**REDUCTION OF LANDSLIDE VULNERABILITY BY MITIGATION MEASURES  
PROJECT (RLVMMP) FUNDED BY AIIB  
Minutes of Pre-Tender Meeting No-1  
CONTRACT NO: RLVMMMP/GOODS/NCT/04R-LOT 1/2/3/4/5/6/7/8**

**Pre-Tender Meeting** on 17<sup>th</sup> November at 10.00 a.m.

### 3. Following Revisions shall be made to the Tender Document

**Item 7.8 - Center Work Leveling Table - Main Laboratory**

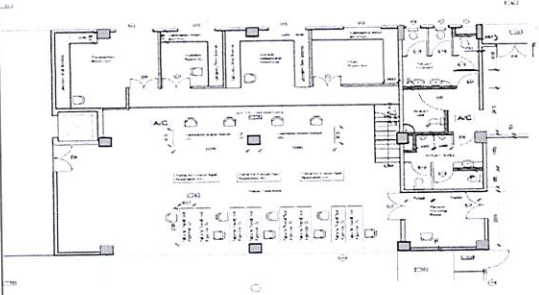
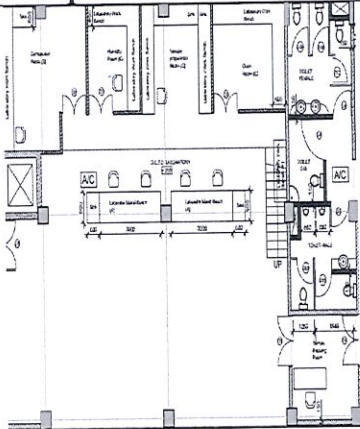
Item No.	Features	Original	Corrected Requirement
7.8.1	Specification	Fixed Drawers for the table (Lockable)	03 Fixed Drawers Cupboards - 1No. (Lockable)
			<b>Add</b> - Fixed cupboard with 02 shelves – 2Nos.(Lockable)

**Item 7.9 - Leveling Table III - Main Laboratory**

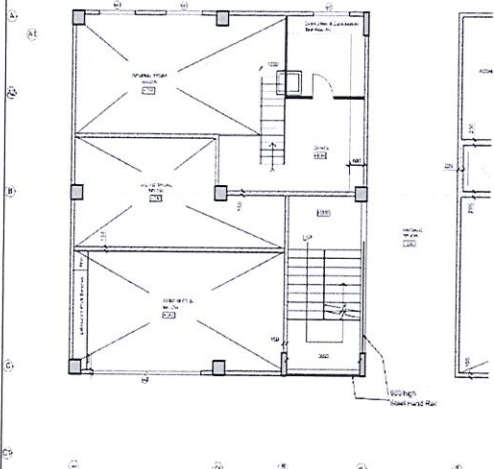
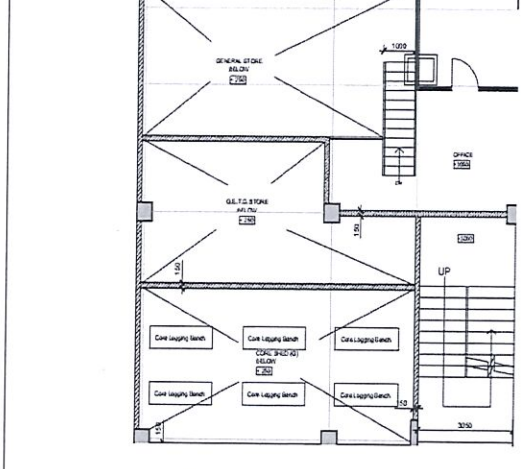
Item No.	Features	Original	Corrected Requirement
7.9.1	Specification	Fixed Drawers for the table (Lockable)	03 Fixed Drawers Cupboards - 1No. (Lockable) Add - Fixed cupboard with 02 shelves - 2Nos.(Lockable)

**Item 7.21 –**

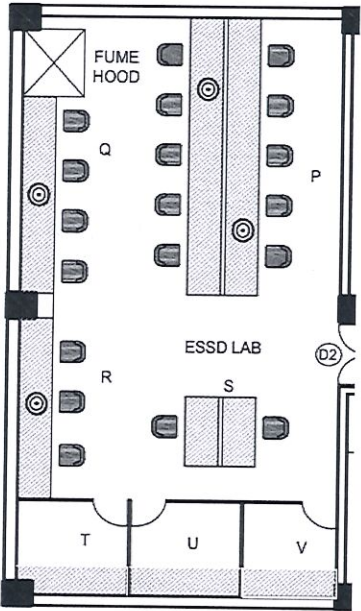
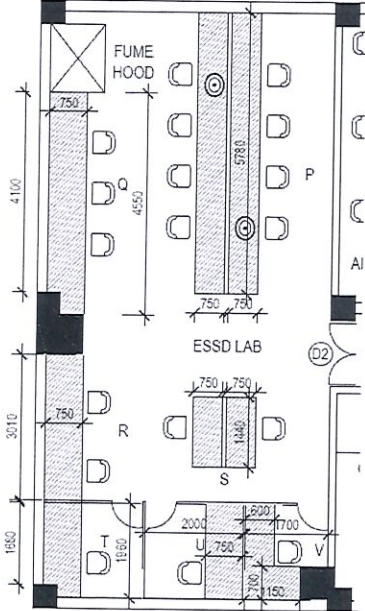
<b>Item No.</b>	<b>Features</b>	<b>Original</b>	<b>Corrected Requirement</b>
7.21.1	Warranty Period	Non corrosive materials, water absorption damages into structural materials and termite attack (if Board used)	Warranty Period- Two years from the date of installation and commissioning
7.21.5		10. Nos of laboratory chairs should be supplied for (A), (B), (C), (D), (G), (H) & (I) areas. Comfortable, height adjustable, low back support/arm, movable 5 legged base laboratory chairs for the seating requirement.	10. Nos of laboratory chairs should be supplied for (A), (B), (C), (D), (G) areas. Comfortable, height adjustable, low back support/arm, movable 5 legged base laboratory chairs for the seating requirement.
